Official Transcript of Proceedings
NUCLEAR REGULATORY COMMISSION

Title: Advisory Committee on Reactor Safeguards
 ABWR Subcommittee

Date: Wednesday, December 3, 2014

NTTF Recommendation 4.2

ESF Logic and Controls System (ELCS) Block Diagram

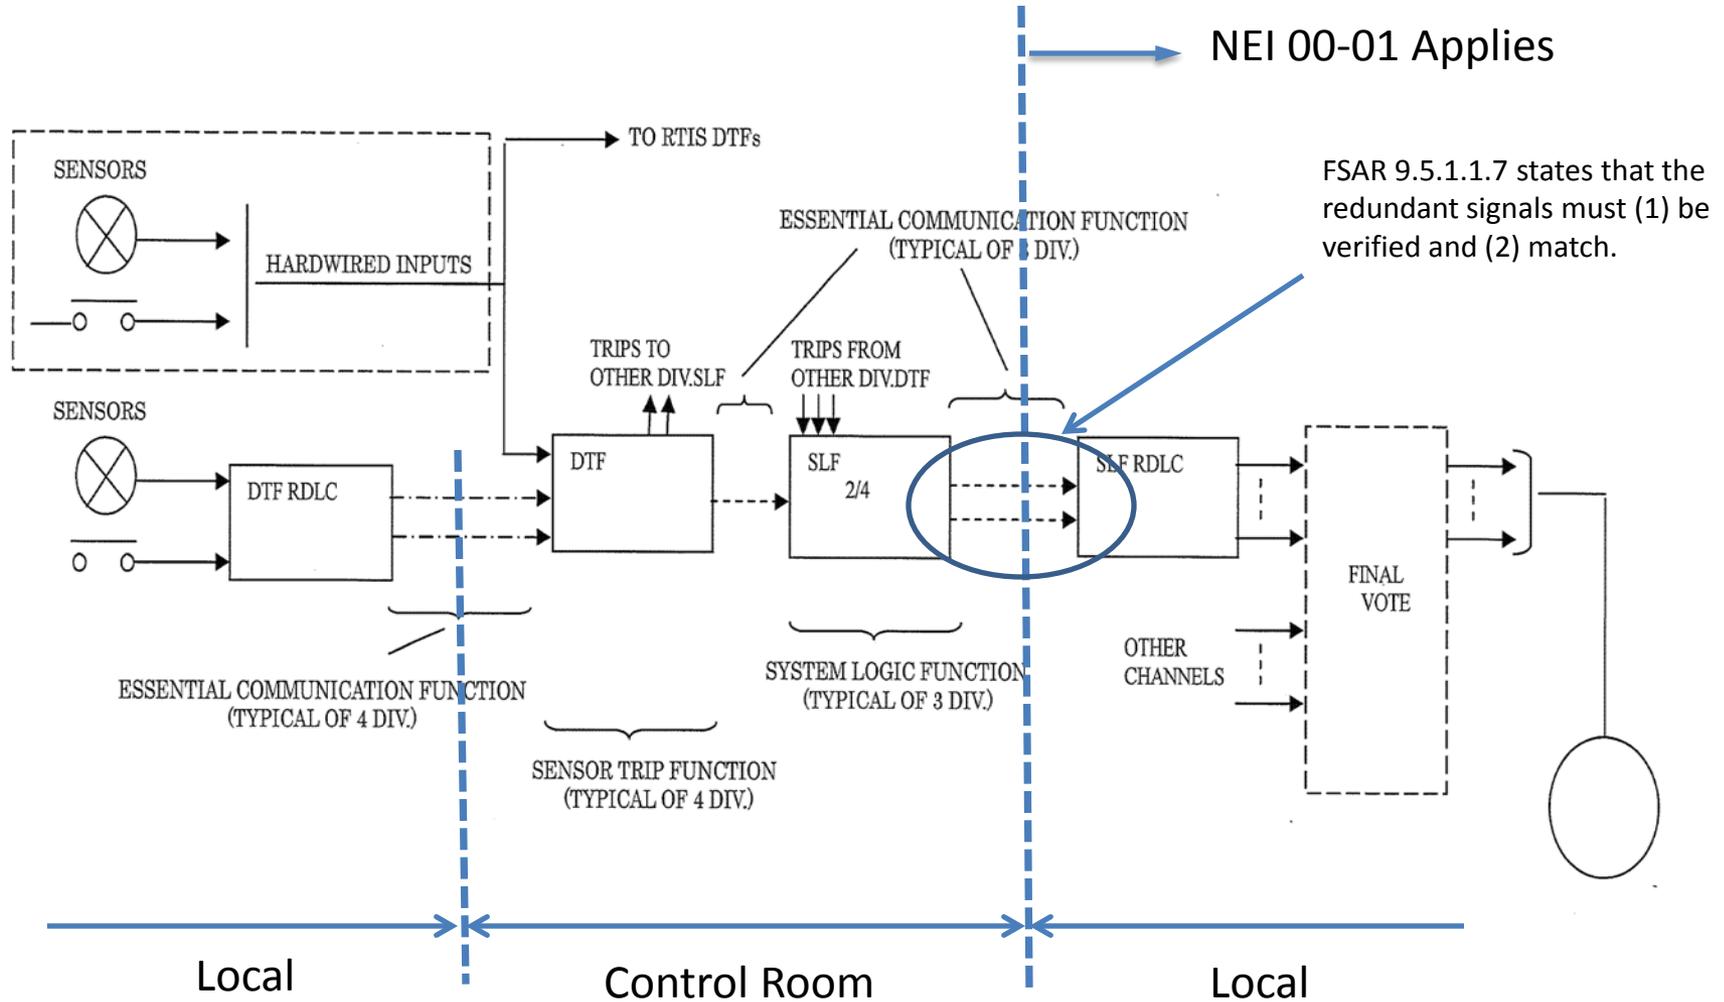
The briefing will also include the NRO staff responding to a question from the Committee members regarding the possibility of spurious signals from digital I&C cabinets with fiberoptic cables under heat from a nearby fire.

ACRS Action Item 64

FSAR 9.5.1.1.7 Spurious Control Actions
